PLANNING PROPOSAL TO MODIFY ZONING, HEIGHT AND FSR TO LAND AT 95-97 STANHOPE ROAD KILLARA - LOURDES RETIREMENT VILLAGE

PURPOSE OF REPORT: For Council to consider a Planning Proposal at 95-97 Stanhope Road, Killara on land currently operating as Lourdes Retirement Village.

Table of Assessment – Planning Proposal – 95-97 Stanhope Road, Killara

Section E

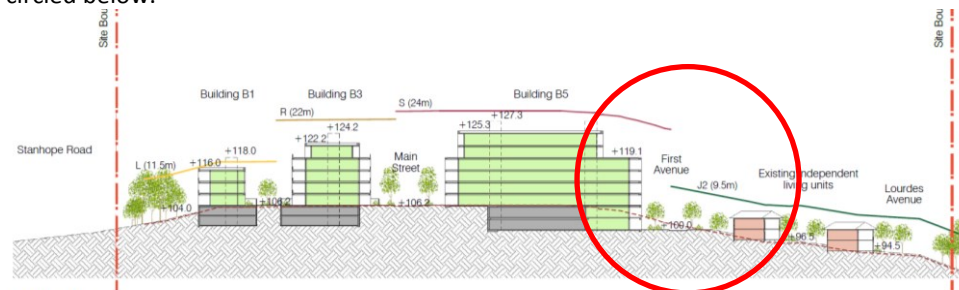
A key issue regarding the outcomes depicted in this urban Design Study is the lack of interface consideration with low density residential development on the site itself, on the neighbouring site at 91 Stanhope, and to Headfort House which has been found worthy of local listing. Some of the bulk, massing, scale issues are circled below.

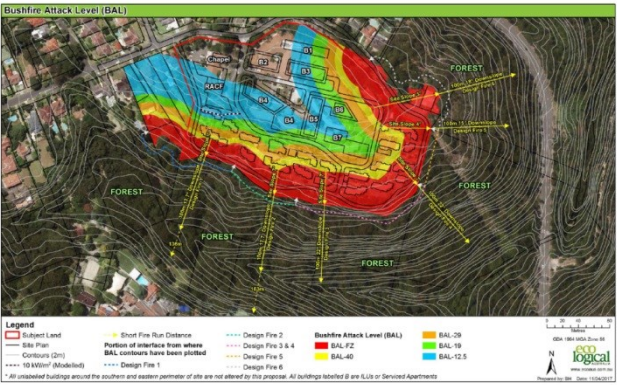
<p>5-6</p>	<p>Section 2 of the report undertakes a Bushfire Threat Assessment.</p> <p>The effective slopes shown in Figure 2 have been agreed to by NSW RFS Development Assessment and Planning Officer Josh Calandra after a site inspection on the 6.10.16.</p>	<p>Figure 2 below (taken from the Independent Review of Bushfire Impact, Australian Bushfire Protection Planners Pty), identifies some minor discrepancy in the effective slope identified on Figure 2 [Slope Assessment] in the Bushfire Protection Assessment.</p> <p>The effective slope is that slope within the hazard (i.e. under vegetation) which most significantly affects fire behaviour.</p> <p>Whilst it is understood that the RFS has agreed to the effective slopes used within the Planning proposals Bushfire Threat Assessment, an additional assessment was undertaken by Council’s bushfire consultant (Independent Review of Bushfire Impact, Australian Bushfire Protection Planners Pty). This assessment was undertaken using 2m LIDAR derived contour data and shows either equivalent or greater effective slopes than that assessed within the Bushfire Protection Assessment (see figure 2 below). Resulting in a potential increased rate of spread inherent to fire travelling upslope.</p> <p>It is suggested that the effective slope applied within the current or future Bushfire assessments be reviewed to assess discrepancies raised.</p>

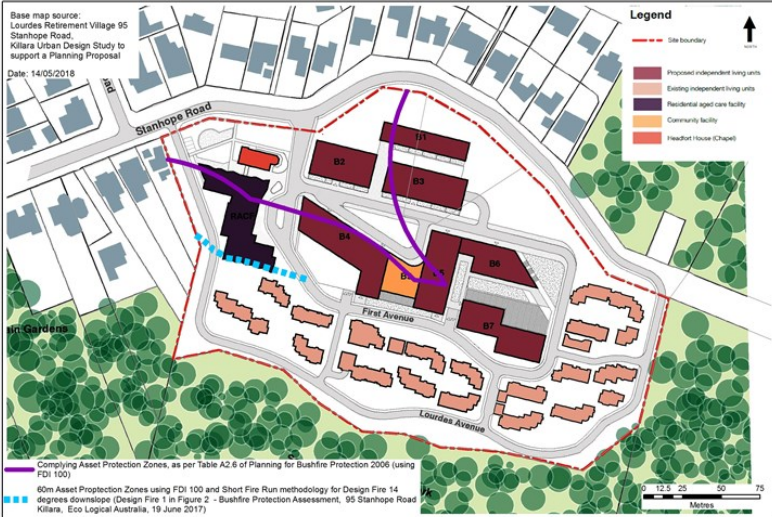
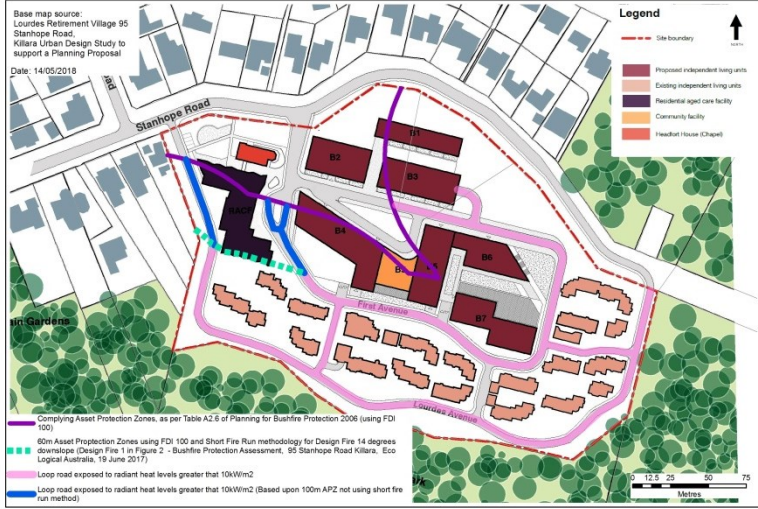
15-16	Section 8 examines the existing and proposed access arrangements under the Planning Proposal with the proposal		<p>The Planning Proposal provide a secondary access to Stanhope Road. This improves emergency egress from the site except that the existing perimeter access road linking to the secondary exit is not safe and will be subject</p>

<p>to provide a secondary access to Stanhope Road.</p>	<p>to bushfire over-run.</p>  <p>The Planning Proposal establishes a loop perimeter internal road identified as ‘First Avenue’. A review of the likely impact on this road has identified that with the use of the increased Fire Danger Rating for the site the north-eastern, eastern and south-eastern sections of the loop will be exposed to radiant heat levels greater than 10kW/m². This section of the loop road will therefore not provide safe access/egress for residents and an operational platform for fire-fighters assisting during bushfire. Refer to Figure 4</p>
<p>17</p>	<p>Section 9 examines emergency response and evacuation.</p>	<p>The following concerns with emergency response and evacuation are raised:</p> <ul style="list-style-type: none"> • Due to the inaccuracies in the determination of the APZs, the assessment of the safety of the occupants is also incorrect and evacuation in the event of bushfire will therefore be required. • All the properties (including 95-97 Stanhope Road) within the catchment area, mapped in Figure D, exit on Stanhope Road, which is the only exit road from this catchment area. A Bushfire Evacuation Risk Assessment has been undertaken to understand current and potential impacts to this area. The methodology used is the same as applied to Council’s Deferred Areas Planning Proposal, which was supported by the NSW Police and Rural Fire Service and recently endorsed by the NSW Department of Planning. The results of this analysis show: <ul style="list-style-type: none"> ○ The catchment area has a total of 256 dwellings currently existing, exceeding the recommended maximum 50 dwellings for the one exit road (Stanhope Road) by 206 dwellings. ○ The amendments sought by the Planning Proposal would result in a total of 486 dwellings within the total catchment area, exceeding the recommended maximum 50 dwellings for the one exit road (Stanhope Road) by 436 dwellings. • The egress from this catchment area is inadequate in the event of evacuation from bushfire event:

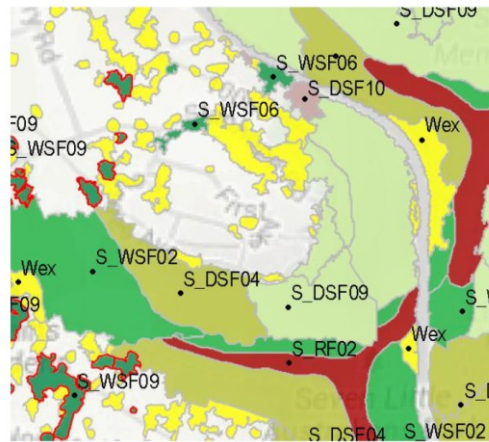
13	<p>Section 4.1 <i>“There are no extensive naturally occurring or reconstructed ecological communities occurring on site (Figure 3). A small patch of woodland including two individuals of Turpentine and one of Sweet Pittosporum occurring at the western section of the subject land (Figure 4) may be derived from genotypic material from a former distribution of Sydney Turpentine Ironbark Forest that would have been aligned with the edges of the Wianamatta Shale/Hawkesbury Sandstone stratification boundaries (Figure 3.)”</i></p>	<p>Council supports the position that the site supports Sydney Turpentine Ironbark Forest under the <i>NSW Biodiversity Conservation Act 2016</i>.</p> <p>Analysis of Aerial photograph within the site from 1943 to 2016 (see appendix 1 below), shows persistent vegetation within areas mapped by the NSW Office of Environment and Heritage as Sydney Turpentine Ironbark Forest (as shown within Figure 3 of the Ecological Assessment).</p> <p>The vegetation assemblage, landscape and soils within these areas are consistent with the scientific listing of Sydney Turpentine Ironbark Forest under the <i>NSW Biodiversity Conservation Act 2016</i>. It is also consistent in that the determination recognises this community even within areas where the original forest or woodland structure no longer exist (i.e. individual remnant trees).</p> <p>This is clearly supported within point 2,3, 8 and 9 of the <i>Sydney Turpentine-Ironbark Forest - Determination to make a minor amendment to Part 3 of Schedule 1 of the Threatened Species Conservation Act</i>, which states:</p> <p><i>“2. The total species list of the community is considerably larger than that given in 1 (above), with many species present in only one or two sites or in very small quantity. In any particular site not all of the assemblage listed in 1 may be present. At any one time, seeds of some species may only be present in the soil seed bank with no above-ground individuals present. The species composition of the site will be influenced by the size of the site and by its recent disturbance history. The number of species and the above-ground composition of species will change with time since fire, and may also change in response to changes in fire frequency.</i></p> <p><i>3. The structure of the community was originally forest, but may now exist as woodland or as remnant trees.”</i></p> <p><i>8. STIF typically occurs on areas with clay soils derived from Wianamatta Shale, or shale layers within Hawkesbury Sandstone.</i></p>

Figure 1 – Plan of Potential Fire Paths

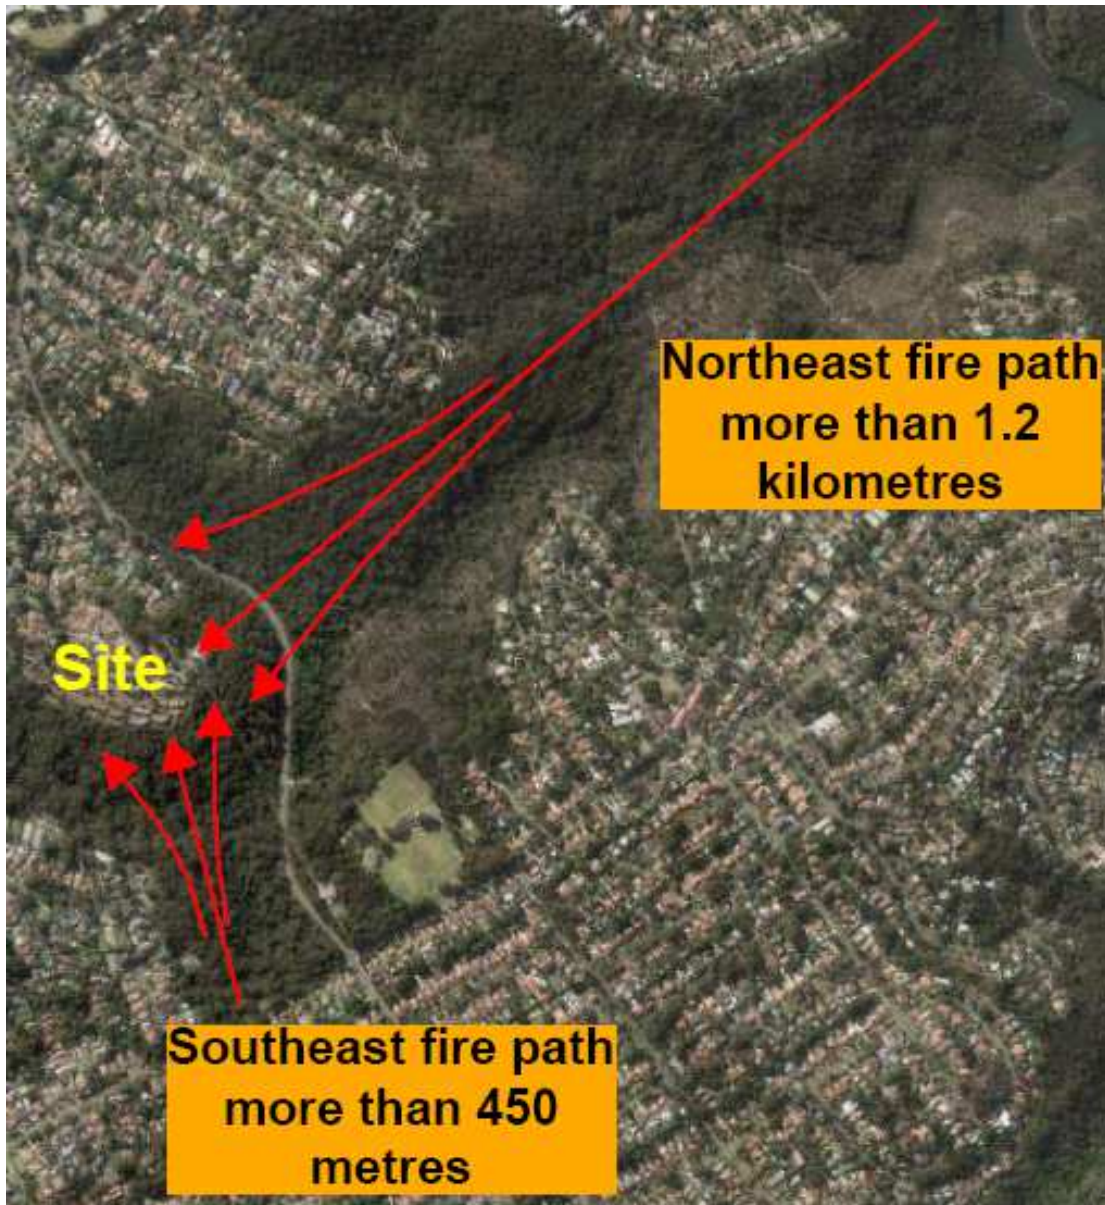
Figure 1 on Page 10 of this report provides a graphical representation of the fire paths which are likely to present a hazard to the site and identifies that there is a 1.2 klms fire path from the northeast with a potential head width of more than 300 metres.

The fire path from the southeast has a length of more than 450 metres with a potential head width of more than 250 metres.

Figure 3 – Plan showing 100 metre and 60 metre wide Asset Protection Zone setback line.

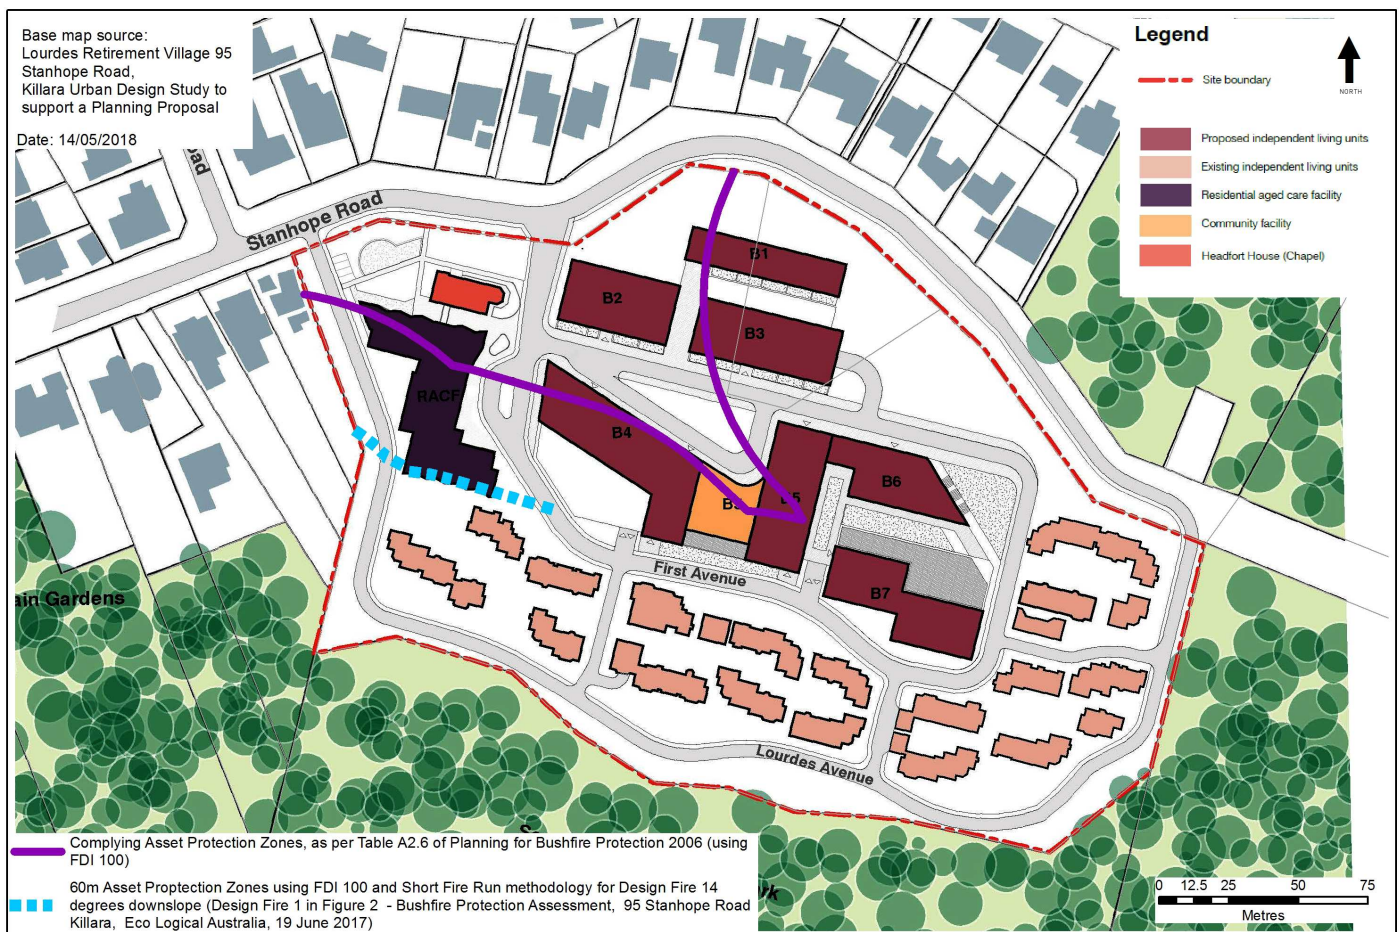
As a result of the NSW Rural Fire Service not accepting the use of an FDI of 55, the default mechanism for determining complying Asset Protection Zones is Table A2.6 of *Planning for Bushfire Protection 2006*.

Table A2.6 *Planning for Bushfire Protection 2006* requires that for effective slopes of more than 10 degrees, having forest as the predominant vegetation type, the Asset Protection Zone is 100 metres in order to achieve a radiant heat rating on the exterior of the buildings of no greater than 10kW/m².

Figure 3 on Page 13 of this report showing the 100 metre wide Asset Protection Zone setback line.

The ELA report utilises a Short Fire Run calculation to justify the Asset Protection Zone setback to the southwest. The maximum length of fire path [run] accepted by the Rural Fire Service in Short Fire Run calculations is 150 metres.

Except for the Design Fire 14 degree downslope fire path to the southwest, which has a fire run distance of 147 – 150 metres, all other fire paths exceed the 150 metre length and therefore preclude the use of the Short Fire Run Calculator. The Planning Proposal provides a setback of around 58m (but a required APZ of 55 metres) to the southwest of the new RACF building. Using the Short Fire Run methodology and FDI 100, a distance of 60m is required to provide radiant heat of less than 10kW/m² to this aspect of the building, as mapped within Figure 3

Figure 4 – Plan showing location of high risk access road.

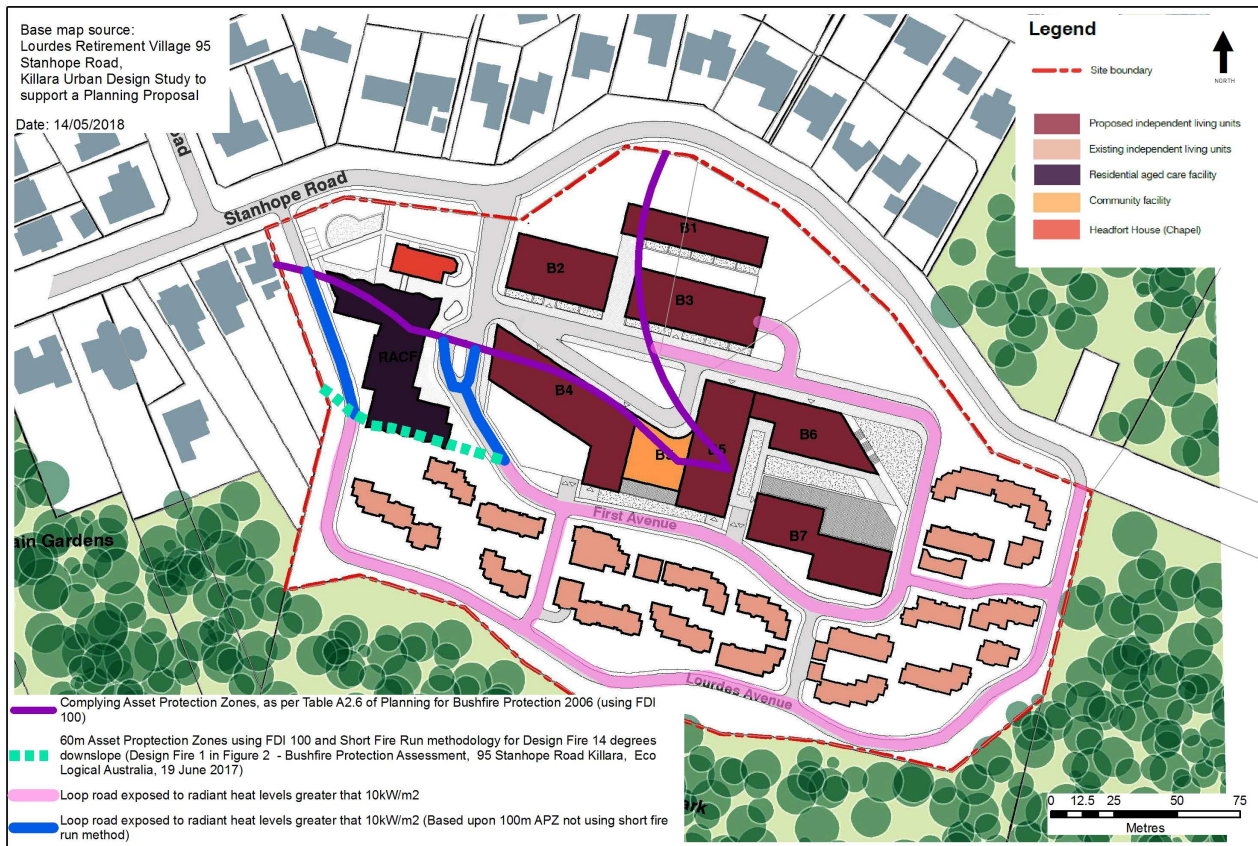
Section 8 of the ELA report examines the existing and proposed access arrangements under the Planning Proposal with the proposal to provide a secondary access to Stanhope Road. This improves emergency egress from the site except that the existing perimeter access road linking to the secondary exit is not safe and will be subject to bushfire over-run.

The Planning Proposal establishes a loop perimeter internal road identified as 'First Avenue'. A review of the likely impact on this road has identified that with the use of the increased Fire Danger Rating for the site the north-eastern, eastern and south-eastern sections of the loop will be exposed to radiant heat levels greater than 10kW/m². This section of the loop road will therefore not provide safe access/egress for residents and an operational platform for fire-fighters assisting during bushfire. Refer to Figure 4 on Page 15 of this report.

Figure 5 – Plan showing 100 metre wide Asset Protection Zone setback and 29kW/m² (61m) setback line.

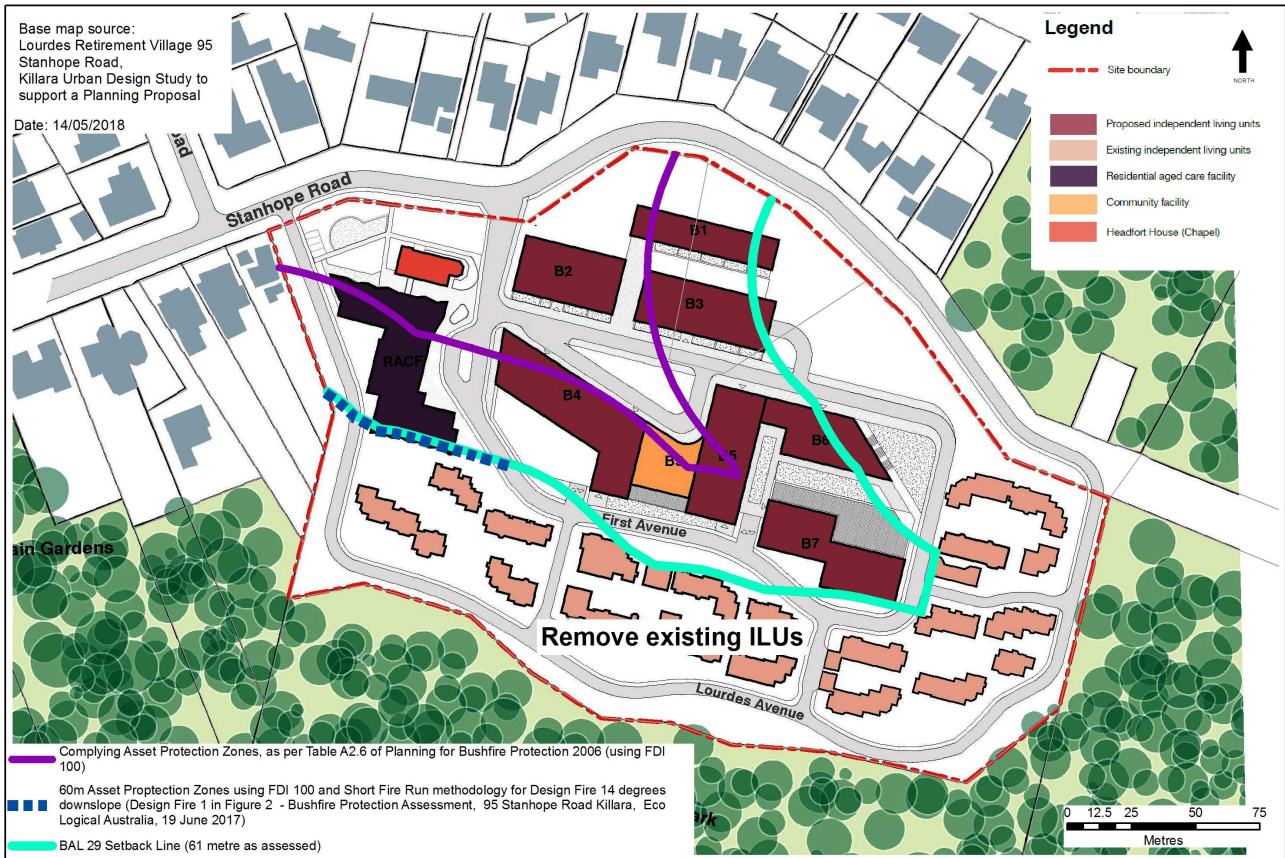
The existing ILUs proposed to be retained on the periphery of the site shall be removed and the area managed as an Asset Protection Zone. The existing perimeter road shall be retained for fire-fighting and maintenance access and the internal road redesigned to provide access to the buildings and a second connection to Stanhope Road, located inside the 10kW/m² setback – refer to Figure 5 on Page 18 of this report.

The occupancy numbers shall also be reduced to lower the number of persons requiring evacuation from the buildings located in the 29 kW/m² setback distance. This will depend on the NSW Rural Fire Service's acceptance of an increase in the radiant heat level from 10kW/m² to 29kW/m².
